# **Technical Report - Supporting Data and Analysis for Skagit River RFIS Appeal**

March 2011

**City of Burlington  
City of Mount Vernon  
City of Sedro-Woolley  
Town of La Conner**

Pacific International Engineering, PLLC

Figure 24. Comparison of COE Original and PIE Revised FLO-2D Model Levee Alignments

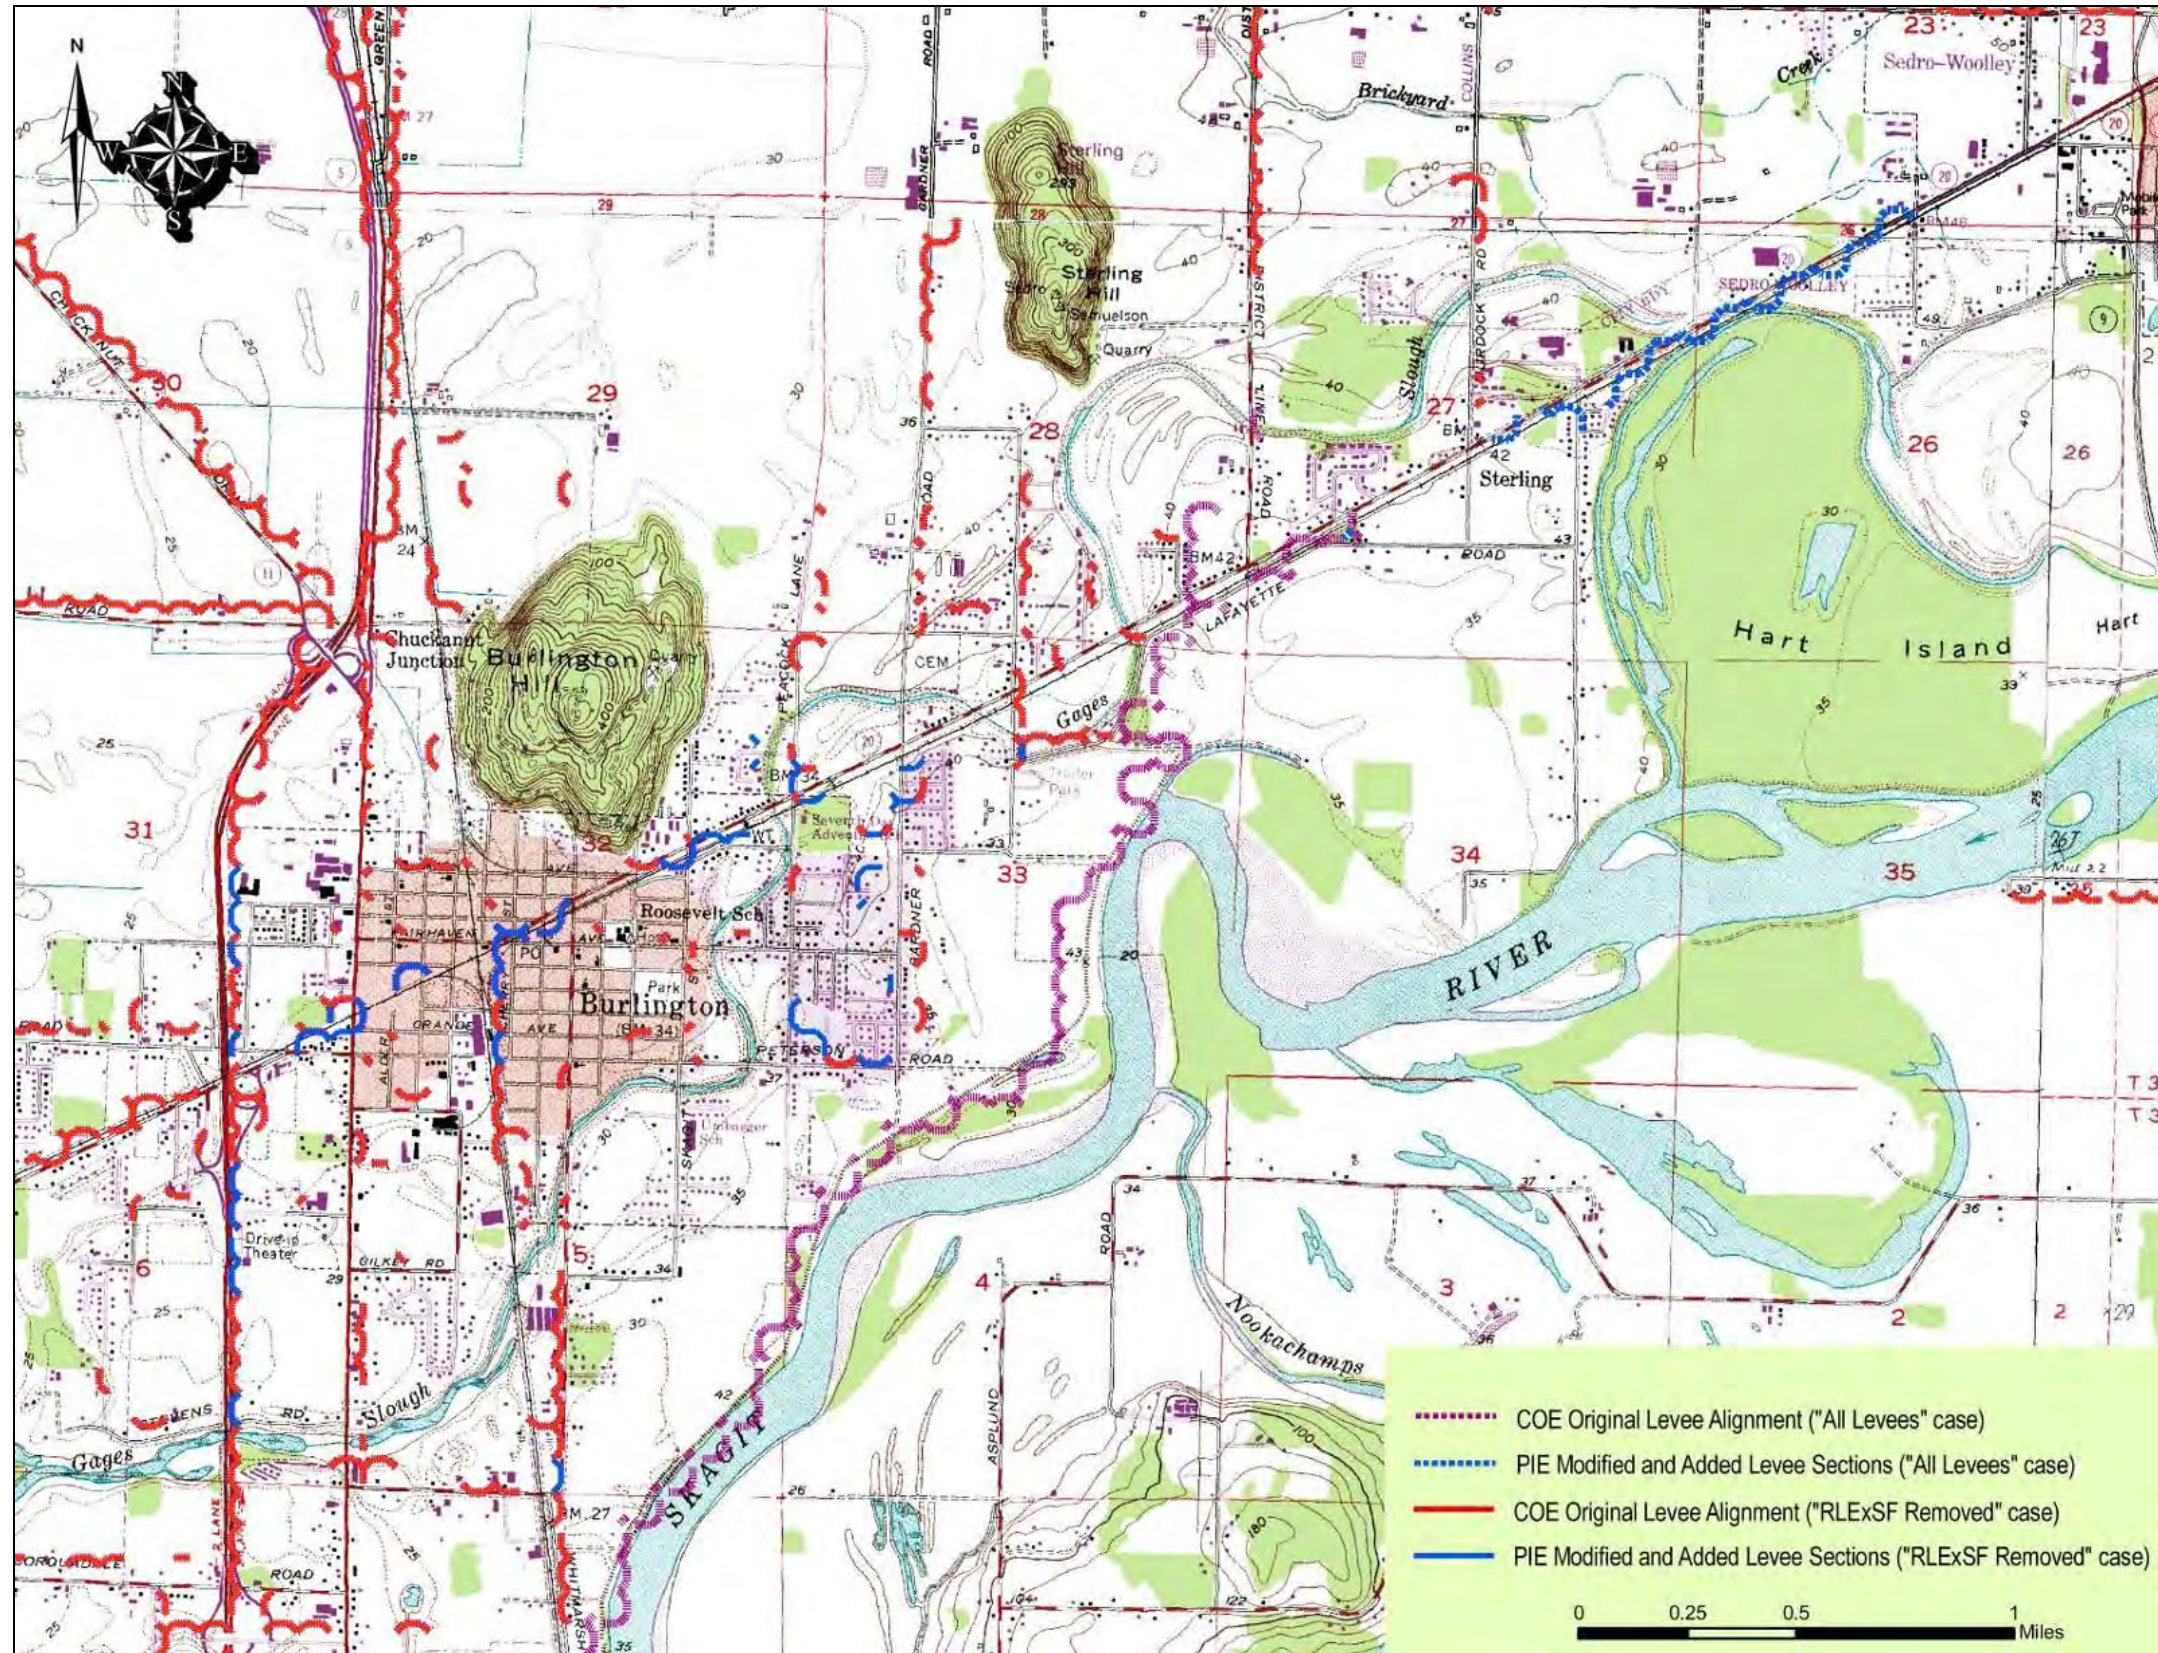
Figure 24 shows the FLO-2D model levee alignments revised by PI Engineering to include the extension of this 1.2-mile right-bank uncertified levee, in comparison with the model levee alignments originally developed by the COE. The figure also shows other PI Engineering revised levee segments representing

high ground or road fill in the City of Burlington and Gages Slough floodplain area. These levee revisions are based on recent and more accurate topographic data collected by the City of Burlington in this area, which are discussed in the next section.

- (2) Adding or deleting other segmental levees representing high ground or road fill in the City of Burlington and Gages Slough floodplain area as shown in Figure 24.

Figure 25. Cell Ground Elevation Difference between PIE Revised and COE Original FLO-2D Model

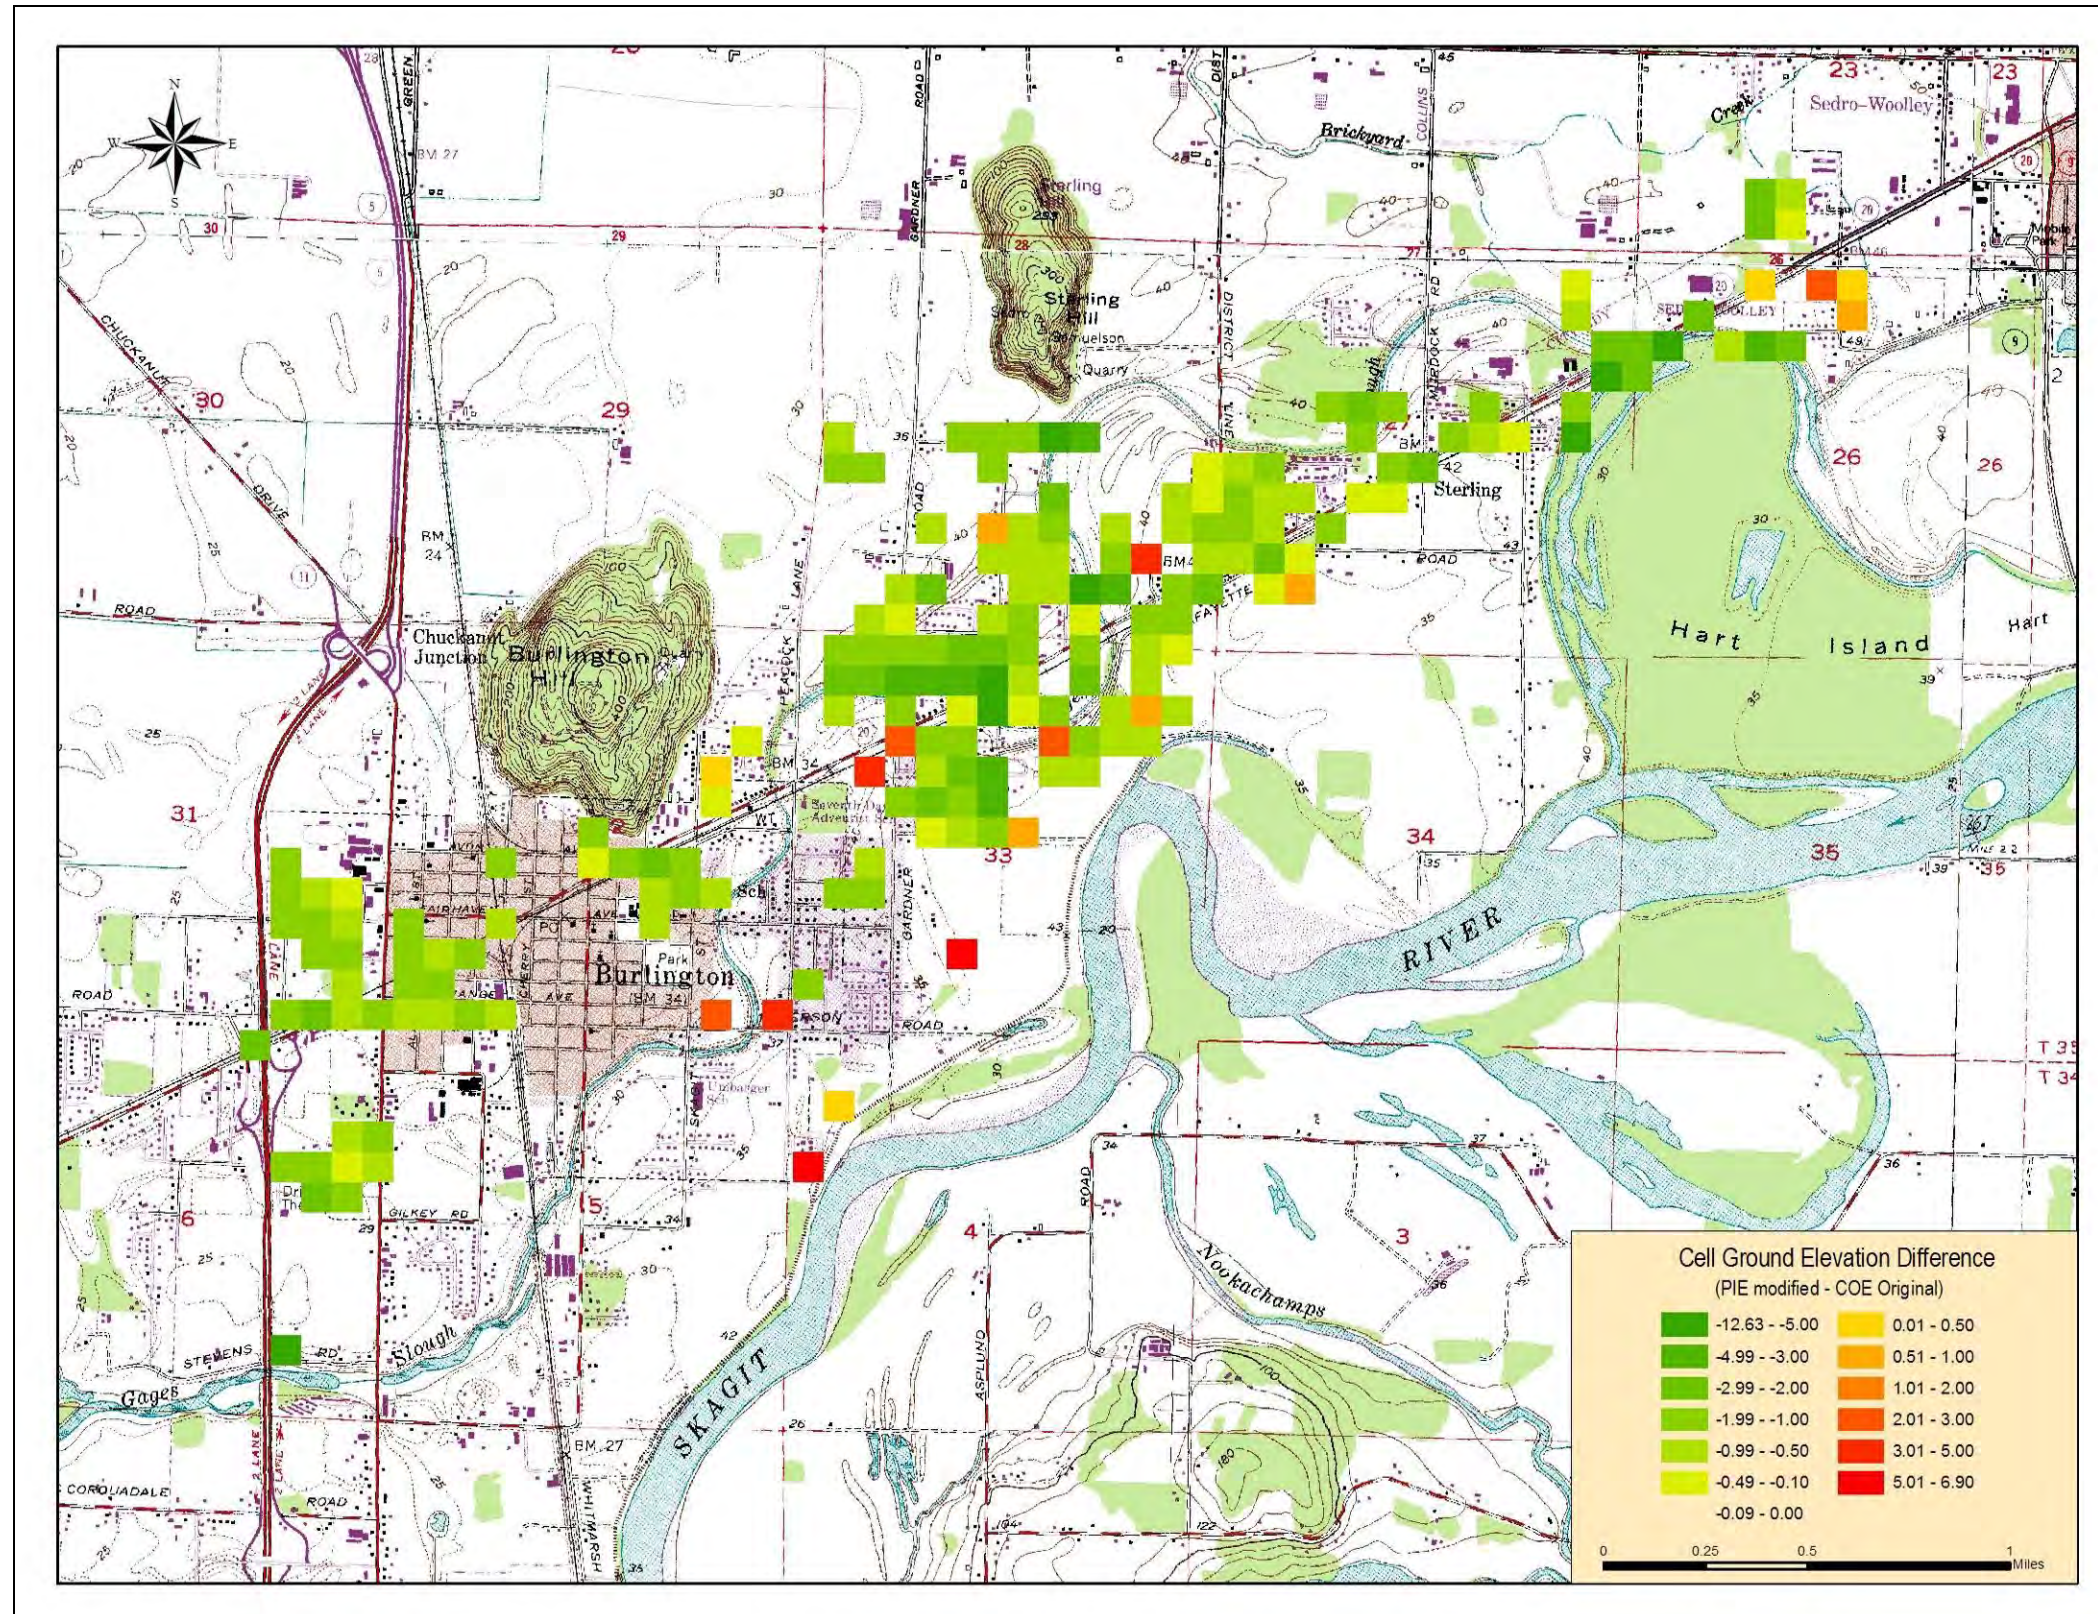
- (5) Revising the grid cell ground elevations as indicated in Figure 25 which shows the cell ground elevation difference between our revised model and the COE original model.
